Fire Safety Standards Advisory Group (FSSAG)
Matter Discussed in the 63rd FSSAG Meeting held on 1 September 2020

Appendix 2a
(Final version)

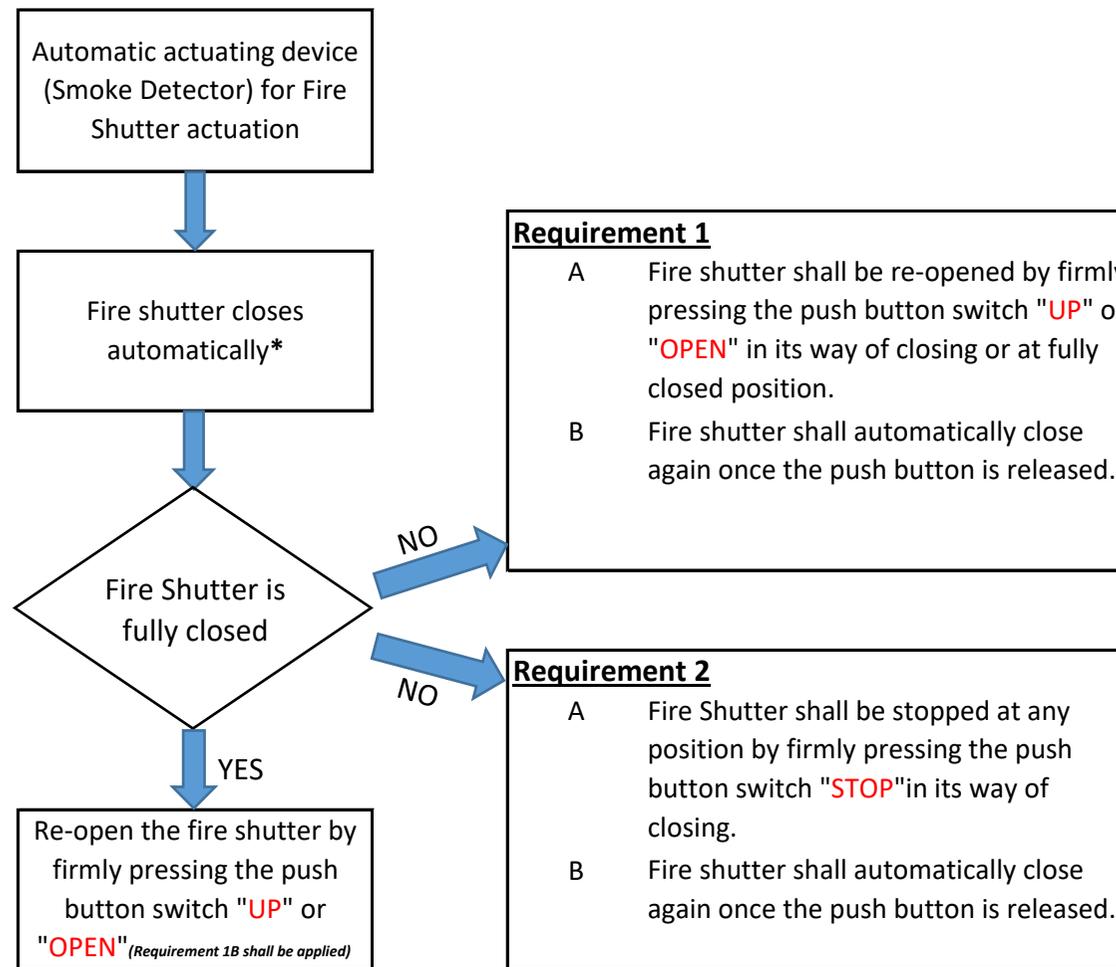
The operation procedures depicted in Appendix 2a for the sake of arriving a commonly agreed procedures for operating fire shutters by manual control on both sides of the shutters in acceptance inspection.

A revised Appendix 2a with clear operation procedures with statutory requirements added. Members after checking the revised Appendix 2a agreed to the principle for adoption and FSD would further refine the flow chart for appending to the Minutes of this meeting. (The refined flow chart is appended as [**Appendix 2a** (final version)]).
